ASSESSMENT REPORT

Camden Gas Project Stage 2: Mt Taurus – Harness Racing Club Section 75W Modification (DA 183-8-2004-i Mod 2)

Figure 3: Twinning of gas gathering line

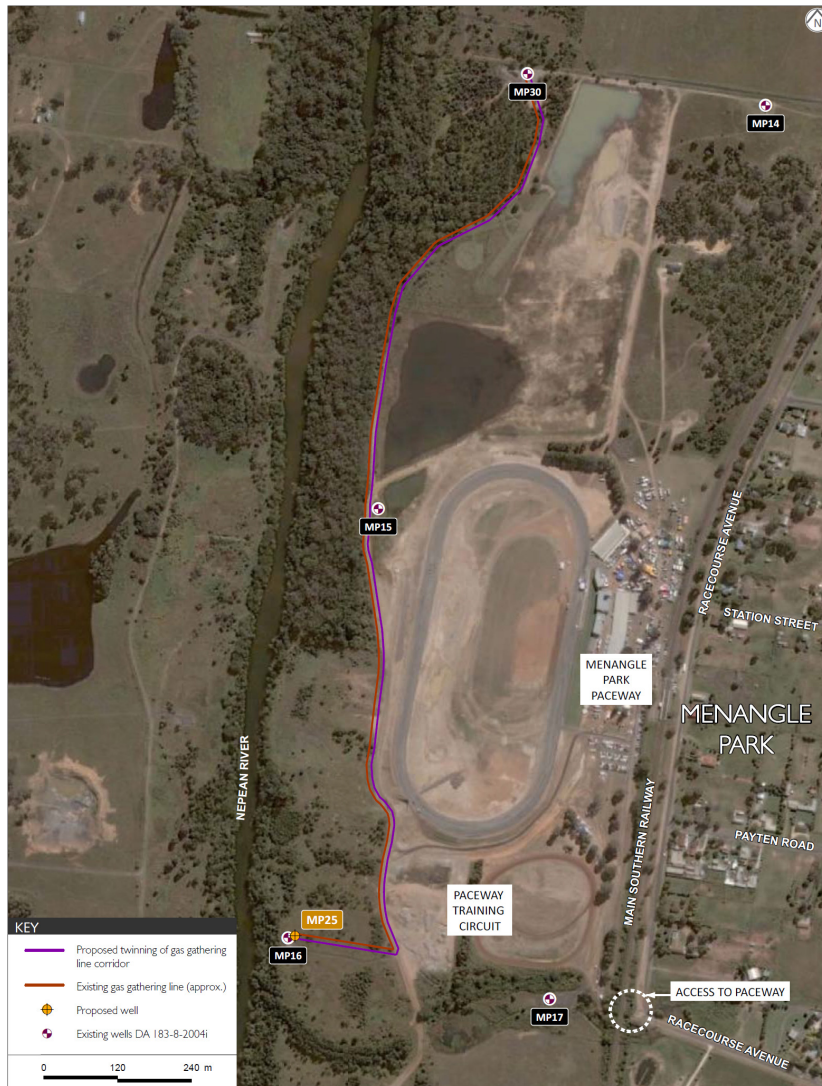
On 17 February 2012, AGL provided a formal Response to Submissions (RTS) to the Department (see **Appendix E**). The RTS provided comprehensive responses to the various agencies' comments and also proposed some minor additional works involving the upgrade ('twinning') of the existing gas gathering line

between the MP16/25 site and the MP13/30 site to the north. The Department forwarded the RTS to the agencies.

The proposed construction and 'twinning' of a gas gathering line involves trenching to depths of between 750 mm and 1,200 mm, installation of pipe adjacent to the existing pipe, backfilling of topsoil and rehabilitation of the ground. The Department considers the proposed twinning of the gas gathering line between gas well sites MP16 and MP30 is unlikely to cause any impacts on surface water due to the short duration of the construction and the minor nature of the works. Nevertheless, the Department has developed a set of model conditions for gas gathering lines and has included them in the recommended conditions of consent. These include ensuring that:

There is one listed EEC (the Riverflat Eucalypt Forest on Coastal Floodplains) located in the riparian corridor along the Nepean River, which at its nearest point is 10 metres from the proposed works associated with the twinning of the gas gathering line between the MP16 and MP30 gas wells. The EA states that this EEC is a “no go zone” and no works are proposed within the drip line of the trees. This is reflected in the Statement of Commitments, which forms part of the recommended conditions of consent.

- the route of the gas gathering and water transport systems and access tracks follow previously or currently disturbed areas wherever practicable;
- open trenching works within 20 metres of watercourses are only undertaken during dry weather conditions; and
- construction activities do not impede lateral water flows.

The Department is satisfied that impacts on the EEC are highly unlikely as the proposal is a sufficient distance from the riparian zone and is located within an already disturbed area. The Department has also included recommended conditions of consent specifically relating to the gas gathering line, which requires various mitigation measures to be undertaken including the minimisation of impacts to riparian vegetation and EECs. The Department is satisfied that these conditions, along with the conditions relating to surface water management and borehole construction, would prevent any potential impacts to the EEC.
